MAYFLOWER PLATINUM

Details of Additions & Alterations

Flat No	703	Block no.	'A' ✓
Flat Area	1500 sft	Type	Deluxe / Luxury
Buyer Name	Bahadur Singh Malik		
Phone No.	9030162115/9849309416	Email

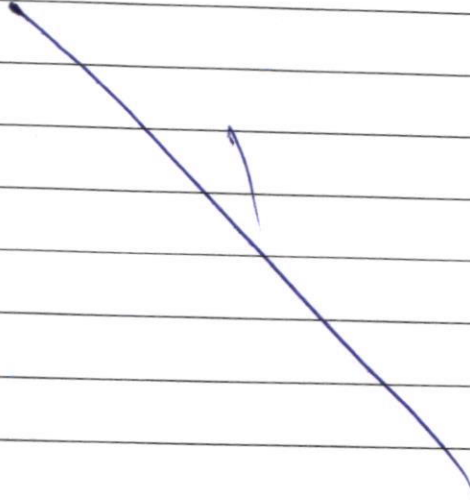
① Bathrooms, utility, balcony Tiles Customer will buy.

Changes in kitchen platform: (mark on plan)

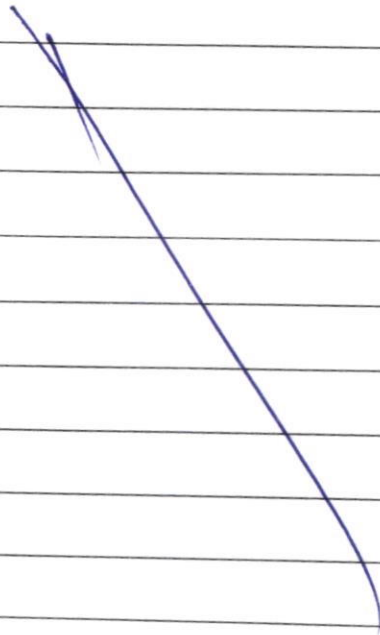
Other Changes: ① Do not assemble kitchen unit
